Radon in Natural Gas from Marcellus Shale
By Marvin Resnikoff, Radioactive Waste Management Associates
Executive Summary*
January 10, 2012

Figure 1. Excerpts from Gamma Ray Logs for (a) Shiavone 2 Well (Reading); (b) WGI11 Well (Dix); (c) Bergstresser Well (Pulteney)

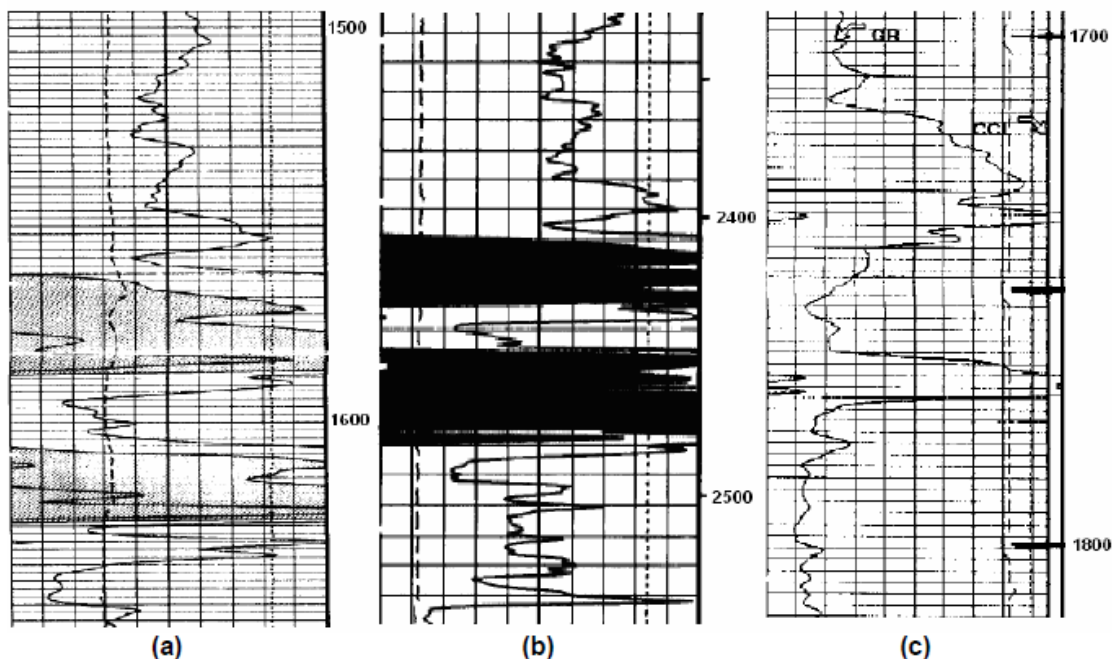
All logs have a provision for the shifting of scale from the standard 0-200 GAPI range to greater than 200 GAPI or even greater than 400 GAPI. It is unclear from the logs how the shifting of scale is recorded, but at a certain depth the gamma ray line indicates measurements beyond the 0-200 GAPI range (Figure 1).

radioactivity can be traced through the depth of the well by following the solid black line. At a certain point this line, which has been recording the gamma ray radioactivity within the 0-200 GAPI range, stops and traces curves that indicate measurements beyond this range for duration of a little less than 100 feet.

The measurements beyond the 0-200 GAPI range are found at the following depths: In the well log for the Reading, NY well (Shiavone 2), this occurs approximately between 1550 and 1650 feet, in the well log for Dixon, NY (WGI11) this occurs between 2400 and 2500 feet, and in the log for the Bergstresser well in Pulteney, NY we see it between 1700 and 1800 feet. These sections of increased radioactivity represent the Marcellus shale.

In each case the thickness (less than 100 feet) and the depth of the shale is consistent with the general geological predictions of the Marcellus formation in the region. It is not possible to give the specific radioactivity measurement due to the log quality, but if we consider that these sections indicate the gamma ray range of 200-400 GAPI, it would represent radioactive radium concentrations of about 12-24 pCi/g or higher. These radium concentrations are far higher than background radium concentrations in New York State¹⁴, which are 0.85 pCi/g.
